ADDENDUM NO. 4

Project: Nunavut Water Board New Office Building
 Location: Gjoa Haven, NU
 Project no: RFP GH 2018-001 TAG:17-017
 Date: March 1st, 2018

SLOPED INSULATION ROOF ASSEMBLY (R-VALUE VARIES, R-52 MIN.)

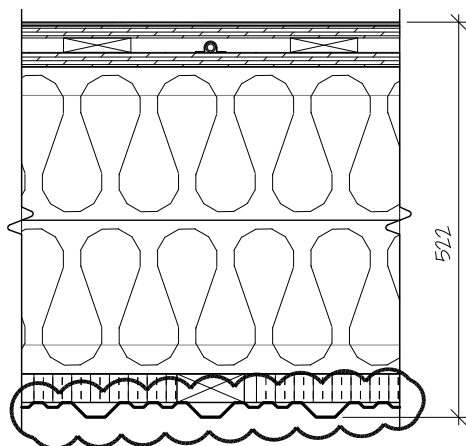
| 23. | A601 | Modification | Assemblies R2, F1, and F2 have been modified. See attached ASK-02 for modified assemblies. |

4 mm GRANULAR SURFACED MODIFIED BITUMEN MEMBRANE CAP SHEET, TORCH APPLIED (MBM)
 56 mm LAMINATED BASE SHEET BOARD, FASTENED TO STEEL Z-GIRTS BELOW (R-12). COVER EXPOSED FASTENER HEADS WITH MBM PATCHES ACCORDING TO MANUFACTURER SPECIFICATIONS.
 102 mm EXTRUDED POLYSTYRENE INSULATION (XPS), FASTENED TO STEEL Z-GIRTS (R-20)
 102 mm GALVANIZED STEEL Z-GIRTS, 600 mm O.C., FASTENED THROUGH LOWER LAYER OF INSULATION TO PLYWOOD SHEATHING
 102 mm EXTRUDED POLYSTYRENE INSULATION (XPS), FASTENED TO PLYWOOD SHEATHING (R-20)
 SLOPED EXTRUDED POLYSTYRENE INSULATION (XPS), FASTENED TO PLYWOOD SHEATHING (THICKNESS AND R-VALUE VARIES)
 1 mm MODIFIED BITUMEN MEMBRANE AIR AND VAPOUR BARRIER, ADHESIVE APPLIED
 16 mm TONGUE AND GROOVE PLYWOOD SHEATHING
 WOOD I-JOISTS PER STRUCTURAL
 CEILING FINISH PER FINISH SCHEDULE
